REFERENCE:	TSB: 08-139-23 REV. A GROUP 08 - Electrical	Date:	July 18, 2023	REVISION:	08-139-23
VEHICLES AFFECTED:	2023 (DJ) RAM 2500 Pickup 2023 (D2) RAM 3500 Pickup 2023 (DD) RAM 3500 Cab Chassis 2023 (DF) RAM 3500 10K LB. Cab Chassis 2023 (DP) RAM 4500/5500 Cab Chassis This bulletin applies to vehicles built on and before May 20, 2023 (MDH 0520XX) equipped with a Global Telematics Box Module (Sales Code RDG).			MARKET APPLICABILITY:	
				<input checked="" type="checkbox"/> NA	<input type="checkbox"/> MEA
				<input type="checkbox"/> SA	<input type="checkbox"/> IAP
				<input type="checkbox"/> EE	<input type="checkbox"/> CH
CUSTOMER SYMPTOM:	Customers may experience one or more of the following: <ul style="list-style-type: none"> • Uconnect Box Message at startup. • Uconnect Box Error or Requires Service Message. • Connectivity: Diagnostic Trouble Codes (DTCs) for Electronic Control Modules (ECUs) won't be shown to customer through the Vehicle Health alert (Mobile app or email).

CAUSE:	TBM software.

This bulletin supersedes Technical Service Bulletin (TSB) 08-139-23, date of issue June 09, 2023, which should be removed from your files. All revisions are highlighted with ****aste

Fig. 1
Uconnect Box Error Message

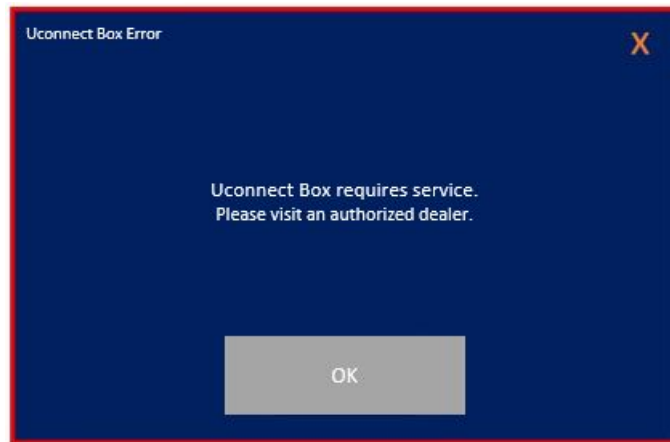
Message display on the radio screen, “Uconnect Box requires service. Please visit an authorized dealer.” (Fig. 1) , with no active or stored DTCs set by the TBM.

NOTE: “Uconnect Box requires service.” message can be triggered by different reasons. For an issue on a new vehicle recently switched to customer mode, please follow the New Vehicle Preparation procedure to resolve the issue. For the customer vehicle with intermittent concerns, please check the TBM, antenna and instrument panel harness connections to fix related DTC issues.

This bulletin provides information regarding the latest Firmware Over The Air (FOTA) update and provides the service technician an overview of the steps a customer will need to take to complete the update. The TBM software will be updated from **5.13 and** 5.25 to 5.39.1.
